# PRODUCT BULLETIN

**Date:** July 22, 2018  
**Update Number:** P2018-15  
**Subject:** LA400/412 New Post Mounting Bracket  
**Product Affected:** LA400PKG, LA400DC/DCS, LA412PKG, LA412DC/DCS

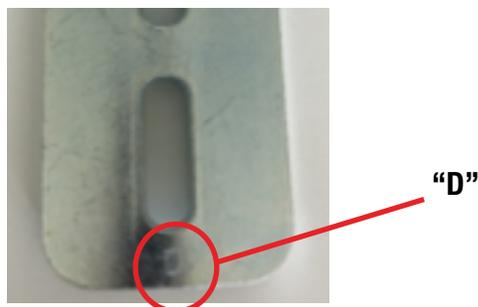
LiftMaster® has improved the post mounting bracket for all LA400 and LA412 Linear Actuator Gate Operators. The new brackets feature a stronger material that is 2x the yield strength to address a small number of reports of the old bracket bending in the field. (Note: this will not address applications where the operator may be installed improperly.)

The new bracket is silver in color and marked with a “D” as indicated in the picture below. It will be shipped with all new LA400 and LA412 Linear Actuator Gate Operators and service kits starting first week of July, 2018.
